Project	<b>IEEE 802.16 Broadband Wireless Access Working Group</b> < <a href="http://ieee802.org/16">http://ieee802.org/16</a> >
Title	<b>Correction of U-TDOA Measurement Procedure</b>
Date Submitted	<b>2007-01-04</b>
Source(s)	Jaesun Cha, Kwangjae Lim, and, Chulsik Yoon <a href="mailto:jscha@etri.re.kr">jscha@etri.re.kr</a> ETRI 161 Gajeong-dong, Yuseong-gu Daejeon 305-700 Korea
Re:	Contribution on comments to IEEE 802.16g/D6
Abstract	Correction of U-TDOA Measurement Procedure
Purpose	Adoption
Notice	This document has been prepared to assist IEEE 802.16. It is offered as a basis for discussion and is not binding on the contributing individual(s) or organization(s). The material in this document is subject to change in form and content after further study. The contributor(s) reserve(s) the right to add, amend or withdraw material contained herein.
Release	The contributor grants a free, irrevocable license to the IEEE to incorporate text contained in this contribution, and any modifications thereof, in the creation of an IEEE Standards publication; to copyright in the IEEE's name any IEEE Standards publication even though it may include portions of this contribution; and at the IEEE

Figure G3 – UTDOA Measurement Algorithm

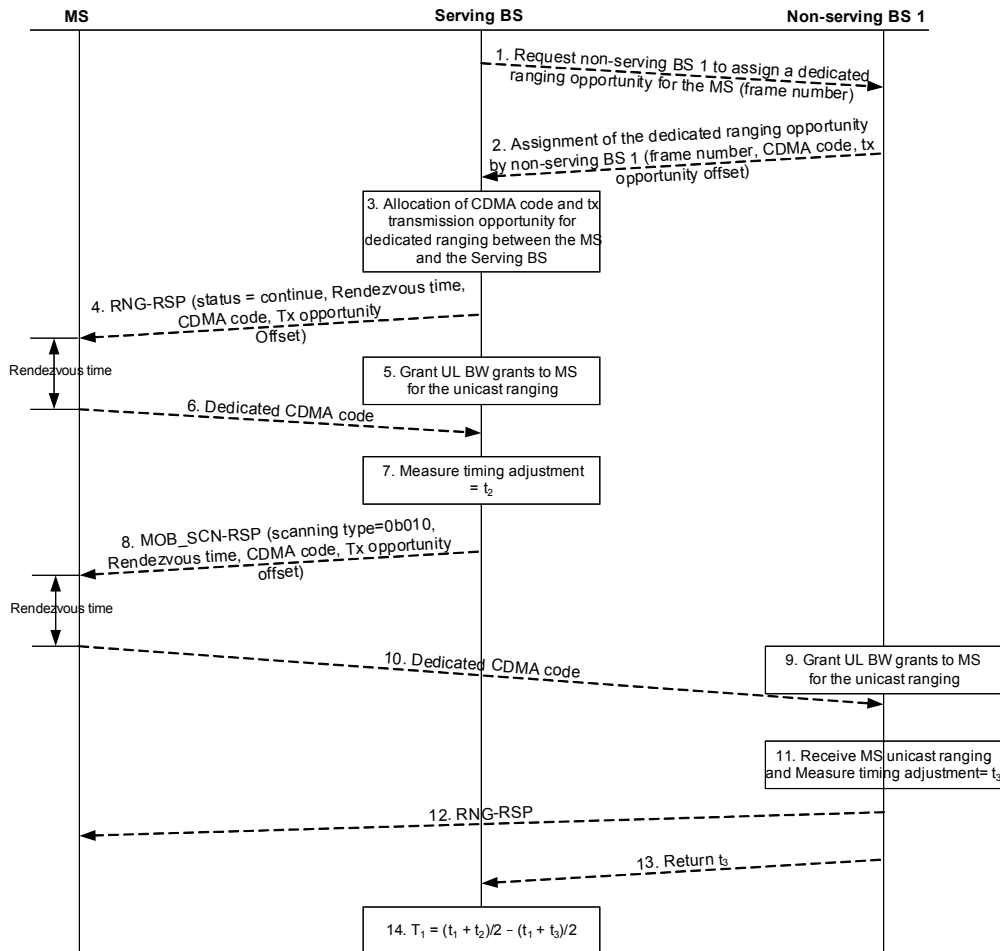
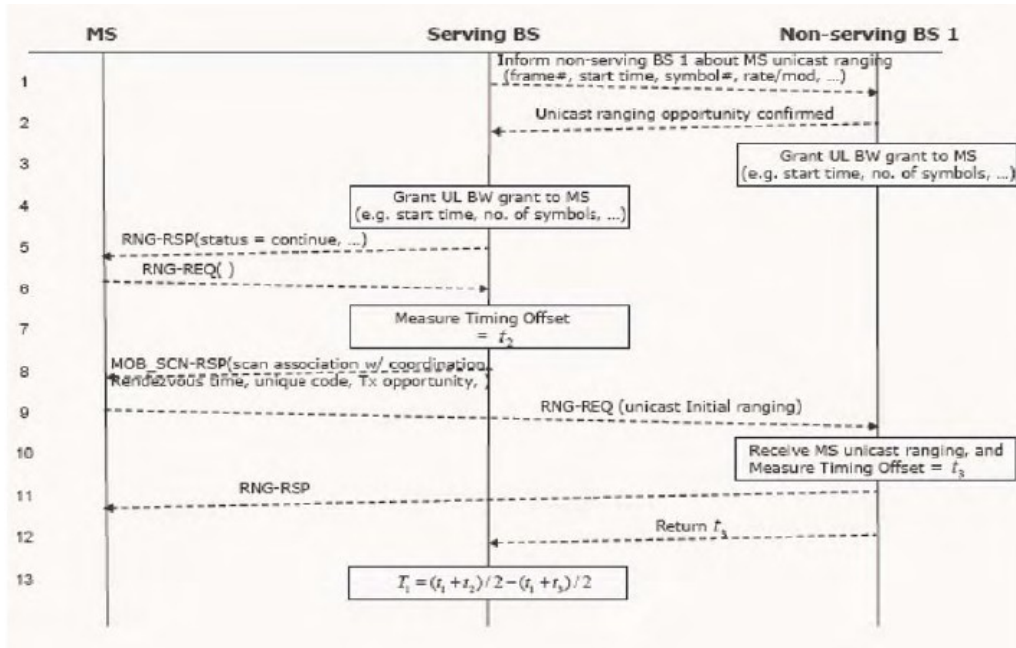
5. ~~Serving BS sends an autonomous RNG-RSP message to ask MS performing unicast ranging~~
6. ~~When MS receives the RNG-RSP from serving BS, it shall send RNG-REQ at the assigned slot~~

7. ~~Serving BS 1 measures Timing Adjustment  $t_2$~~
8. ~~Serving BS sends autonomous MON\_SCN-RSP with scanning type = 0b10 (scan association with coordination) to force MS performing initial ranging after scan~~

9. ~~MS synchronized with non-serving BS 1, and sends RNG-REQ~~
10. ~~Non-serving BS 1 receives unicast ranging, and measures Timing Adjustment  $t_2$~~

11. ~~Non-serving BS returns RNG-RSP to MS~~
12. ~~Non-serving BS returns  $t_2$  to serving BS~~
13. ~~Serving BS reads the Timing Advance  $t_1$  that was captured previously, and calculate U-TDOA~~

1. Serving BS requests non-serving BS 1 to assign the dedicated ranging opportunity for the MS.
  2. Non-serving BS 1 confirms the allocation of the dedicated ranging opportunity for the MS and returns the related parameters used for dedicated ranging between the MS and the non-serving BS 1.

- Frame Number
    - CDMA code
    - Transmission opportunity offset
  3. Serving BS allocates a CDMA code and transmission opportunity for dedicated ranging between the MS and the Serving BS.

4. Serving BS sends an autonomous RNG-RSP message to ask MS performing dedicated ranging. The dedicated ranging information for dedicated ranging between the MS and the Serving BS is included in RNG-RSP message.

- Rendezvous time
    - CDMA code
    - Transmission opportunity offset
  5. Serving BS allocates a UL slot for MS to do dedicated ranging which means “dedicated ranging indicator” bit of the UL-MAP IE shall be set to 1.

6. After the rendezvous time from the reception of the RNG-RSP message, MS sends the CDMA code assigned in the RNG-RSP message at the allocated transmission opportunity offset.

7. Serving BS measures Timing Adjustment  $t_2$
  8. Serving BS sends autonomous MOB\_SCN-RSP with scanning type = 0b10 (scan association with coordination) to force MS performing initial ranging after scan. The related parameters assigned by non-serving BS 1 are included in the MOB\_SCN-RSP message.

- Rendezvous time
    - CDMA code
    - Transmission opportunity offset
  9. Non-serving BS 1 grants UL slot to the MS and sets “dedicated ranging indicator” bit of the UL-MAP IE to 1 to use the allocated region for the purpose of dedicated ranging.

10. After the rendezvous time from the reception of the MOB\_SCN-RSP, MS synchronized with non-serving BS 1, and sends the allocated CDMA code at the allocated transmission opportunity offset.

11. Non-serving BS 1 receives the assigned CDMA code, and measures Timing Adjustment  $t_3$ .
  12. Non-serving BS 1 returns RNG-RSP to MS
  13. Non-serving BS 1 returns  $t_3$  to serving BS

14. Serving BS reads the Timing Advance  $t_1$  that was captured previously, and calculate U-TDOA

Figure G5 – U-TDOA Measurement Algorithm

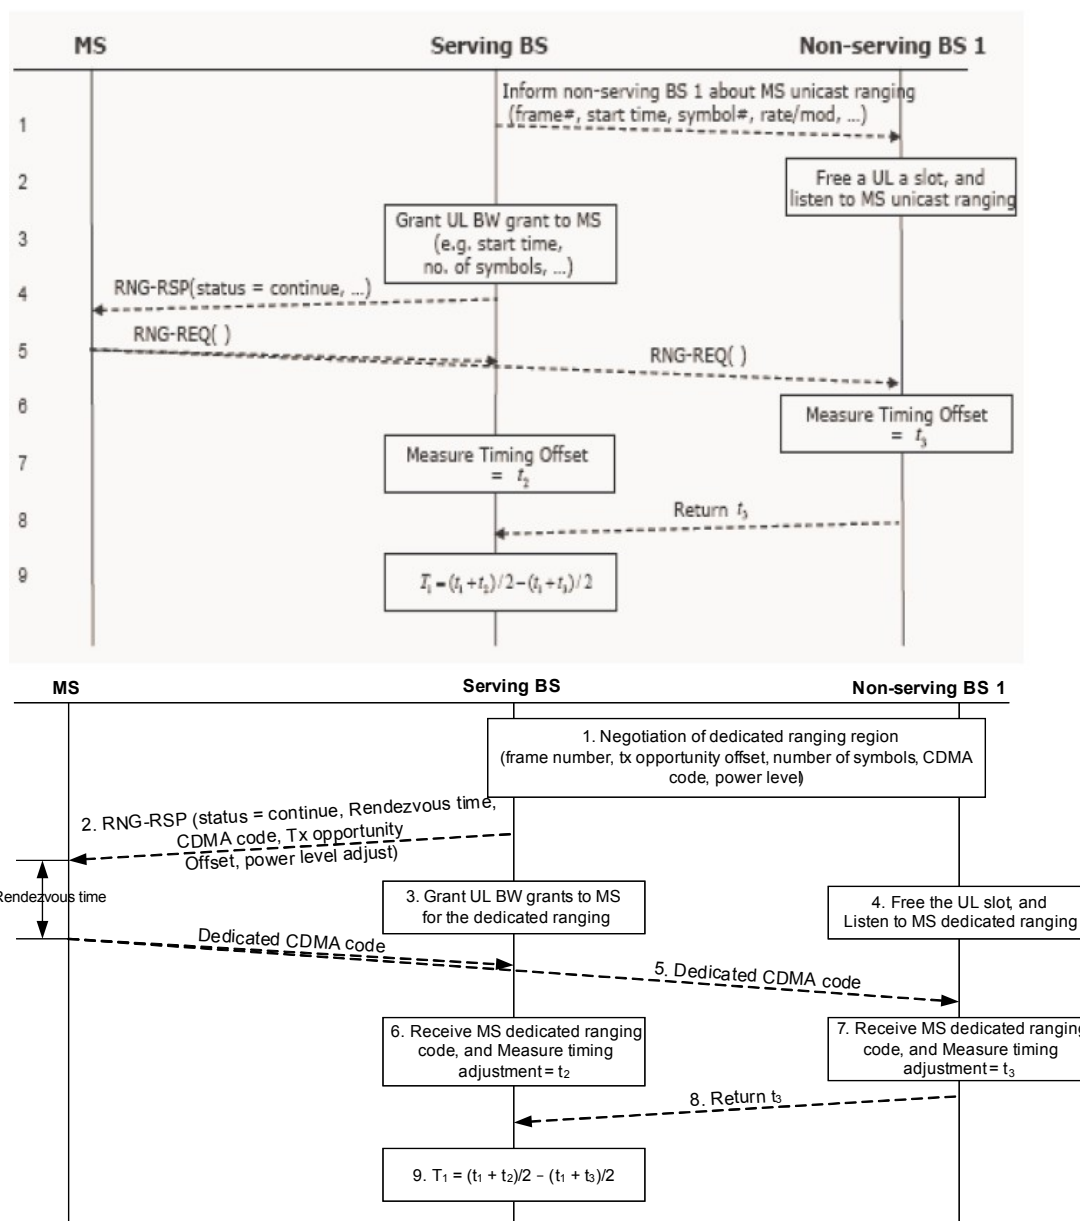
1. ~~Serving BS informs non-serving BS 1 about MS is going to do unicast ranging by passing frame number, start time, number of symbols,~~
  2. ~~Non-serving BS 1 does not grant such UL slot to the MS, and listens to the unicast ranging from MS~~

3. ~~Serving BS allocates a UL slot for MS to do unicast ranging.~~
  4. ~~Serving BS sends an autonomous RNG-RSP message to ask MS performing unicast ranging~~

5. ~~When MS receives the RNG-RSP from serving BS, it shall send RNG-REQ at the assigned slot that can be received by non-serving BS.~~
  6. ~~Non-serving BS 1 measures Timing Adjustment  $t_3$ .~~

7. ~~Serving BS measures Timing Adjustment  $t_2$~~
  8. ~~Non-serving BS 1 returns  $t_3$  to serving BS~~
  9. ~~Serving BS reads the Timing Advance that was captured previously, and calculates U-TDOA~~

1. Serving BS and non-serving BS 1 negotiate the allocation of a dedicated ranging region for the MS.
    - Frame Number
    - Transmission opportunity offset

- Number of Symbols
  - CDMA code
  - Power Level
2. The serving BS sends an unsolicited RNG-RSP message to ask MS performing the dedicated ranging. The dedicated ranging information is included in the RNG-RSP message.

- Rendezvous time
    - CDMA code
    - Transmission opportunity offset
  3. The serving BS allocates a UL slot for MS to do dedicated ranging at the pre-assigned rendezvous time and listens to the dedicated ranging code from the MS.

4. At the same time, the non-serving BS 1 does not grant such UL slot to any MSs at the pre-assigned rendezvous time and listens to the dedicated ranging code from the MS.

5. When the MS receives the unsolicited RNG-RSP from the serving BS, it shall send the dedicated CDMA code at the assigned slot. The transmission power shall be changed based on the power level adjust parameter included in the receive RNG-RSP message to allow the non-serving BS to receive the code successfully.

6. The non-serving BS 1 measures Timing Adjustment  $t_3$
  7. The serving BS measures Timing Adjustment  $t_2$
  8. The non-serving BS 1 returns  $t_3$  to serving BS

9. The serving BS reads the Timing Advance that was captured previously, and calculates U-TDOA
